Access Compliance Report

Public Rights-of-Way

(Curb Ramps)

Intersection ID: 52340	Main Street: FRED_D_ALEXANDER_BV	Cross Street: BROOKSHIRE_BV	Location:	W
ADA ID: DD46479F9AC7	Ramp Type: Perp	Initial Pass/Fail: Fail	Overall Compliance: No	Severity Score: 12.5
Codes/Mitigation Info/Possible Solution		Field Measurements/Component Compliance

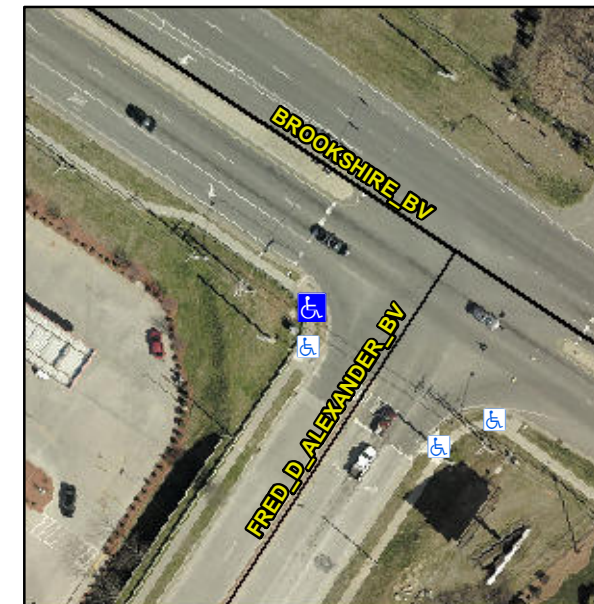
Not Found, R304.5.3

Compliance	Description	Data	Compliance	Description	Data
N/A	Ramp Length (in)	70.0	Yes	Ramp Slope (%)	7.0
Yes	Ramp Width (in)	48.0	No	Ramp XSlope (%)	5.1
N/A	Flare Type LT	N/A	N/A	Flare Type RT	N/A
N/A	Flare Slope LT (%)	N/A	N/A	Flare Slope RT (%)	N/A
N/A	Flare Traversable LT?	N/A	N/A	Flare Traversable RT?	N/A
N/A	Landing Length (in)	N/A	N/A	DWS Provided?	N/A
N/A	Landing Width (in)	N/A	N/A	DWS Contrast?	N/A
N/A	Landing Slope (%)	N/A	N/A	DWS Length (in)	N/A
N/A	Landing X Slope (%)	N/A	N/A	DWS Full Width?	N/A
N/A	Landing Curb? (Y/N)	N/A	N/A	DWS Offset (in)	N/A
N/A	Shared Landing?	N/A			
N/A	Gutter Ponding?	N/A	N/A	Gutter Slope (%)	N/A
N/A	Gutter Lip Ht (in)	N/A	N/A	Gutter X Slope (%)	N/A
N/A	Painted X Walk1?	No	N/A	Painted X Walk2?	N/A
	X Walk 1 Direction	To NE		X Walk 2 Direction	N/A
N/A	X Walk 1 Width (in)	N/A	N/A	X Walk 2 Width (in)	N/A
	X Walk 1 Slope (%)	0.6		X Walk 2 Slope (%)	N/A
	X Walk 1 X Slope (%)	4.6		X Walk 2 X Slope (%)	N/A

Remove & Replace Entire Ramp.
